Department
for Transport

ACPE - 11

UK Definitions: “Maximum Creeping Speed” and “Creeping”

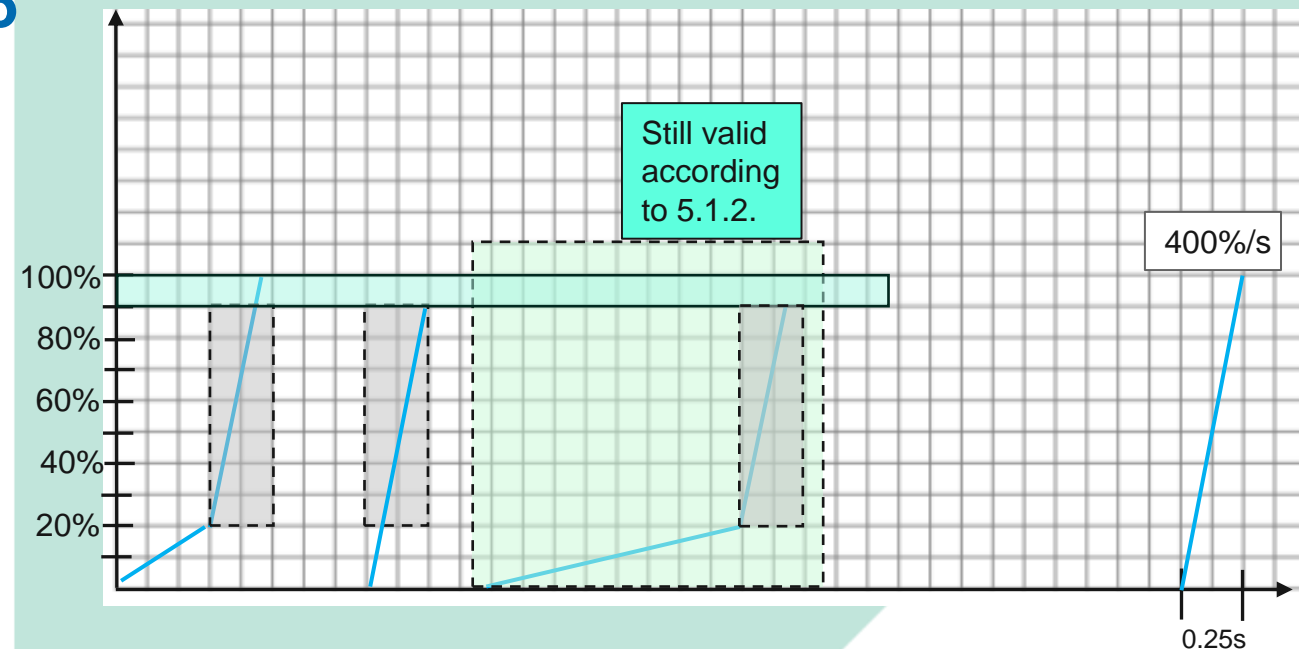
The ACPE shall limit vehicle acceleration in order to prevent or mitigate a collision with an obstacle located ~~between~~ **not more than** ~~[1.0 m and~~ 1.5 m] in front of or behind the vehicle, in the vehicle path, at the time the ~~accelerator control is applied~~ **triggering conditions (as outlined in paragraph 5.1.2.) are reached**, provided:

(d) The situation is unambiguous, i.e.:

... (vii) **The obstacle is located at least 1.0m from the vehicle at the time the triggering conditions (as outlined in paragraph 5.1.2.) are reached;**

(viii) The vehicle is travelling at or below its maximum creeping speed.
